# MicroZed Errata

Thank you for your interest in the Zynq 7Z010/7Z020 MicroZed board. Although Avnet has made every effort to ensure the highest possible quality, these boards are subject to the limitations described in this errata notification. This document pertains to MicroZed Revision B, C, and F boards (revision D & E MicroZed boards were not produced).

## 3.6 USB Host Configuration Resistor

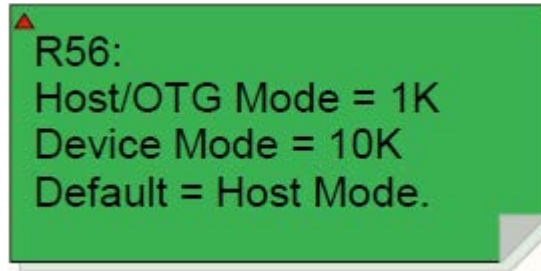
MicroZed uses a MicroChip USB3320 device for the USB Host circuit. On Sheet 5 of the MicroZed schematics, see the following note:

This is incorrect. This resistor is the  $R_{VBUS}$  resistor, which according to the USB3320 is specified to be:

Since the default operating mode on MicroZed is Host Mode, R56 should be 10K $\Omega$  but it is populated incorrectly as 1K $\Omega$ .

Change R56 to 10K $\Omega$ .
